Bulletin 0-3-2

Errors and omissions in 2009 Ontario Electrical Safety Code

Issued January 2010
Supersedes Bulletin 0-3-1

Appendix B note Rule 68-054

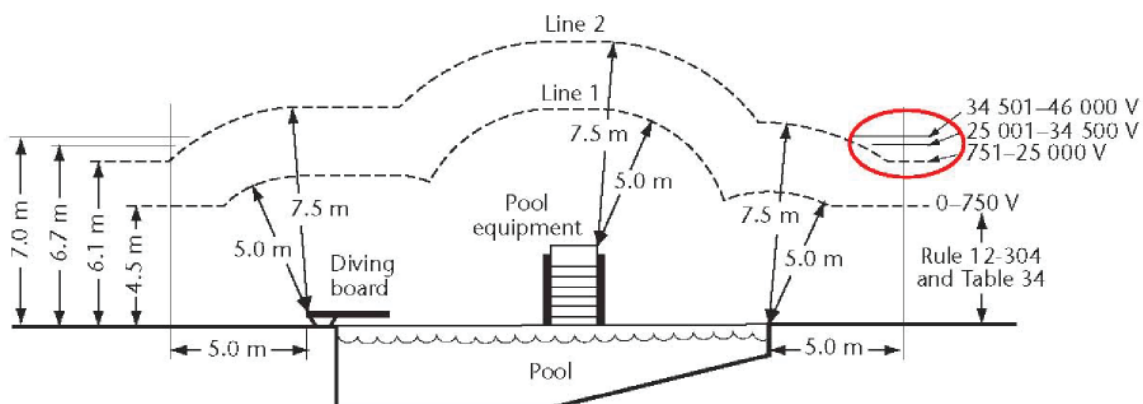
The figure should be replaced with the following (the correction is identified in the circle):
